Subject: **KIA 3.5L LAMBDA II OIL FILTER REPLACEMENT  
vs. the 3.8L oil filter**

This Champion Laboratories Inc. supplied oil filter P989 for the 3.5L Lambda II V6 engine must be used in this vehicle's service, specifically.

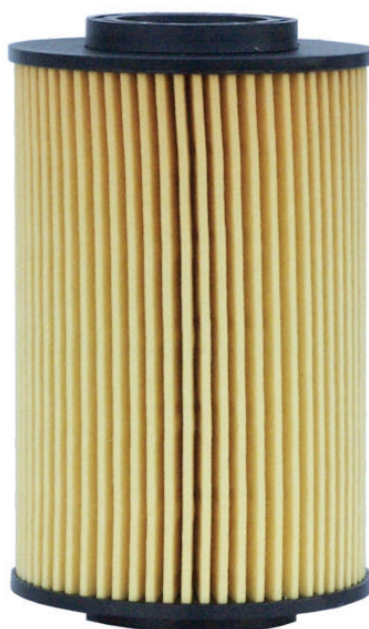
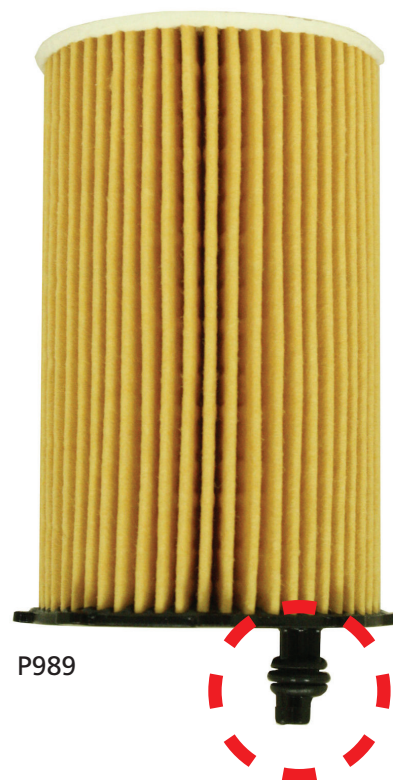
**It is important to use the correct oil filter to avoid engine damage. While the 3.8L oil filter P982 appears similar to the 3.5L P989 filter, it is not interchangeable.**

The 3.5L filter can be easily identified by the plastic post (see photo) on the bottom of the oil filter element. If the drain hole in the 3.5 L filter housing is not plugged by the post, loss of oil pressure can occur. Engine damage that is caused by the use of the incorrect oil filter is not covered under warranty.
